August 3, 2018

Re: Site C Project – Proposed Design Changes to the Halfway River Bridge Design

Table 1. EIS Halfway River Bridge Design Compared to Proposed Design Changes

Figure 7: Halfway River Bridge -- EIS Design versus Modified Design and Environmental Features

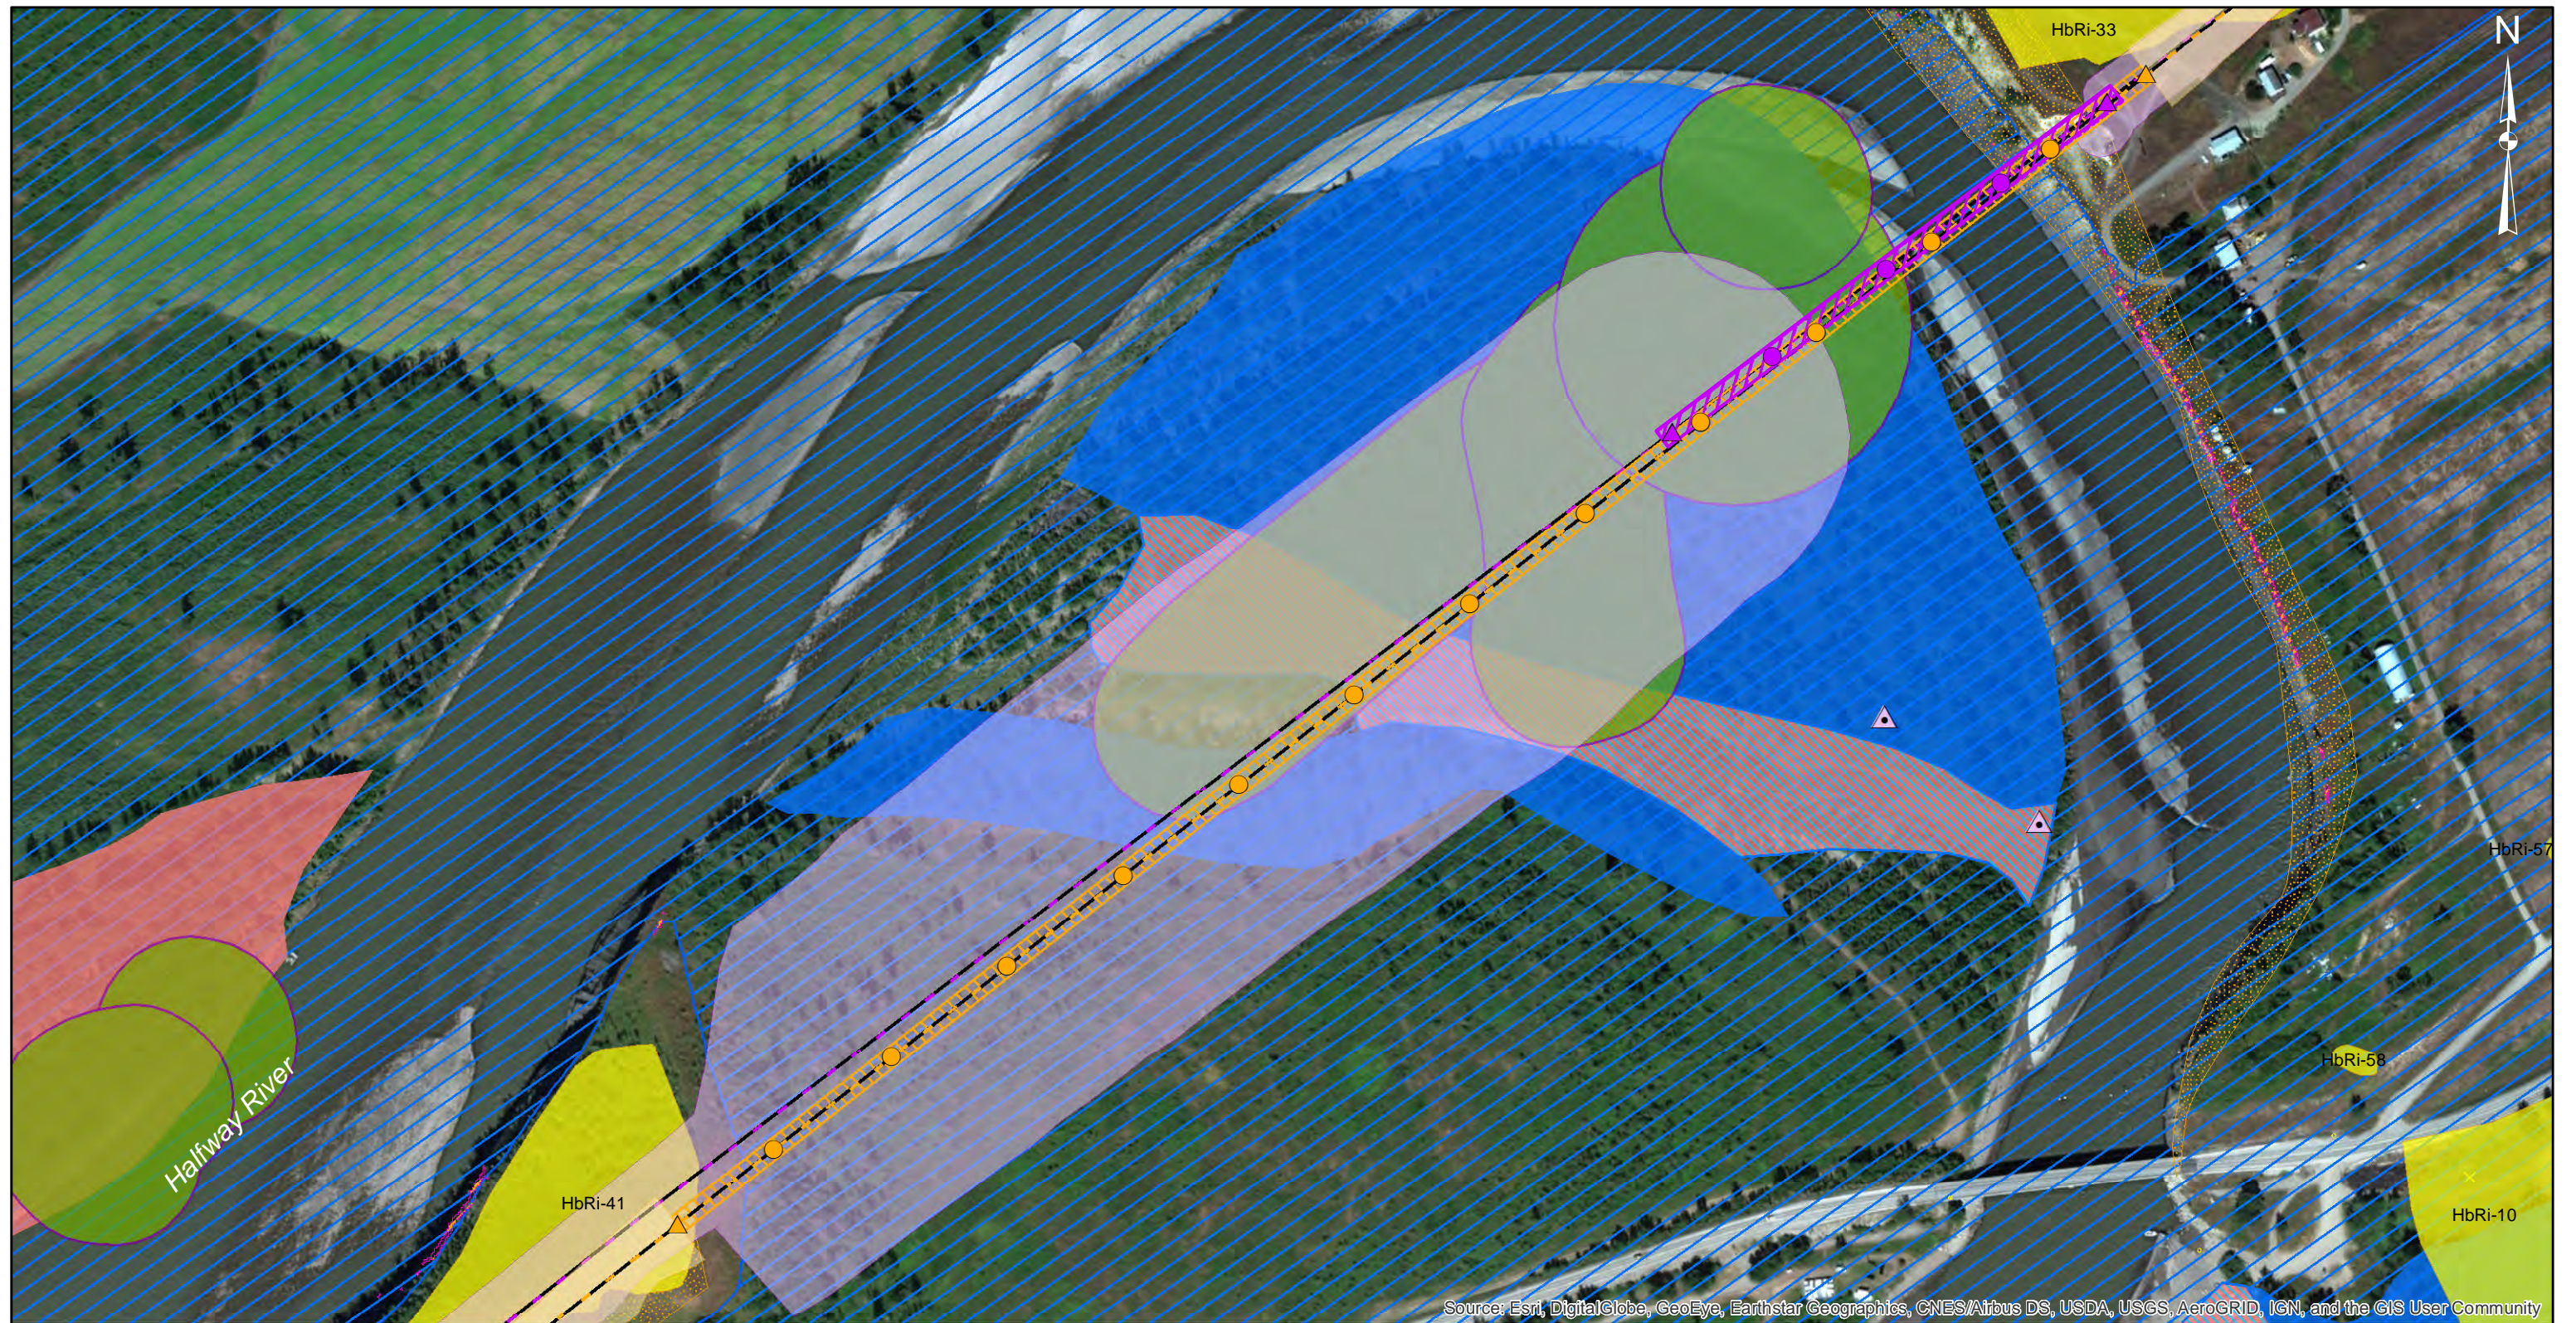
The proposed modification to the Halfway River Bridge design is not expected to cause any additional effects on fish and fish habitat beyond those predicted in the EIS. As shown in Figures 6 and 7, the 640 m causeway per the EIS design will be replaced by piers in the proposed modified design, resulting in a smaller overall riparian and terrestrial footprint of the Halfway River crossing.

The east side of the proposed bridge may encroach on a small portion of an archaeological site HbRi-33 that was previously outside of the footprint (Figure 7). This overlap may result in the need for approximately 10 additional shovel tests, the result of which could trigger a recommendation for further shovel testing or archaeological excavations at the location. This work would be undertaken with participation of Indigenous groups and any archeological finds managed as required under the applicable Acts and Site C Heritage Program.
